PLANNING DIVISION STAFF REPORT

November 13, 2023

Project Address: **405-407 & 431 W Gorham Street, 408-430 W Johnson Street, and 304-318 N Broom Street** (District 3 – Alder Verveer)

Application Type: Demolition Permit, Land Use Restriction Agreement, Zoning Text Amendment, Zoning Map Amendment, Conditional Use, and Certified Survey Map Referral

Image 2: The development's four building 'expressions' (masses)

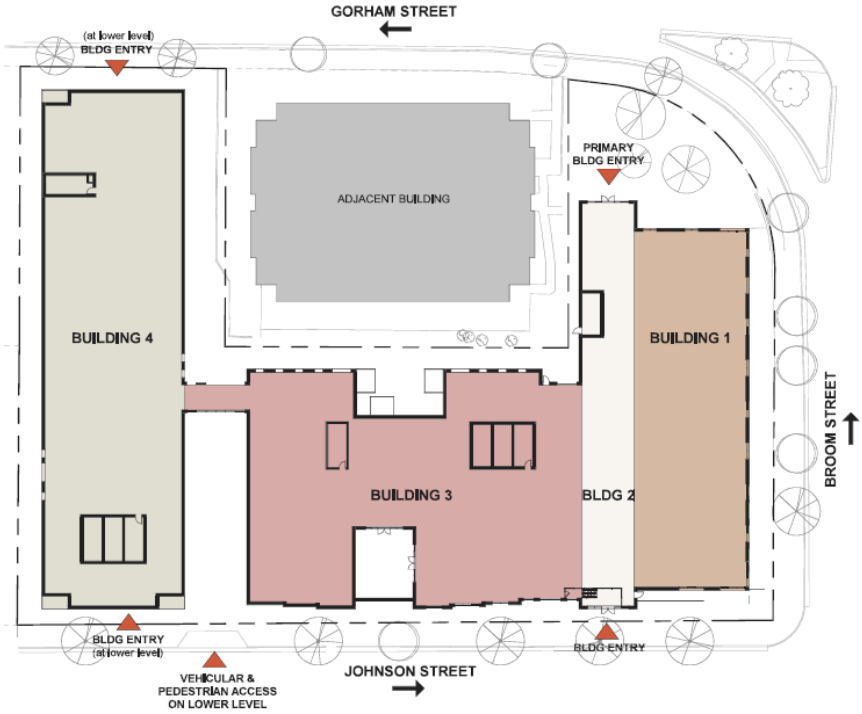
Staff have a few concerns related to the building's design. The first, which was raised at the Urban Design Commission meeting on November 1, is the lack of ground-floor entrances along the entire 185-foot N Broom Street façade as well as roughly 230 feet of the W Johnson Street frontage. Staff note that the UDC at their aforementioned meeting on November 1, added a condition that an additional connection to the street be incorporated along the W Johnson Street frontage. Staff however still believe that an additional entrance is needed along the N Broom Street frontage noting that, if the Building 1 were a stand-alone building, that a primary entrance oriented to the primary abutting street would be required. (Staff acknowledge that an entrance facing W Gorham could meet this requirement if it were located at or wrapped the north corner).

The second concern is the significant blank wall expanse located on the upper floors of the southwest façade of Building 2 (see Sheet 36 "Elevation Promenade Bldg 3" in the submitted materials). The units on the first eight floors of that façade have multiple windows while the units on Floors 9-14 have none, despite the fact that the upper floors would actually afford a view and be less obscured by the adjacent 12-story Equinox building. When brought up to the applicant, they responded with the following, "*As presented to and approved by UDC, this area on the back side of building 2 is predominately bathrooms on the floors 9-14. This is in the narrow section of the building 2 and the design pushes the living room/kitchen/bedrooms to the Broom- and Gorham-facing facades to maximize views. This section of the building is also effectively screened from view by the Equinox as the building is pulled back from the street frontage and the two buildings are closest together along this property line.*" To this end, Staff note that the northwest façade of Building 2 is set approximately 50 feet further back from W Gorham Street than the same façade of the adjacent 12-story Equinox building meaning the views of the section of blank façade from the public right-of-way will be extremely limited.
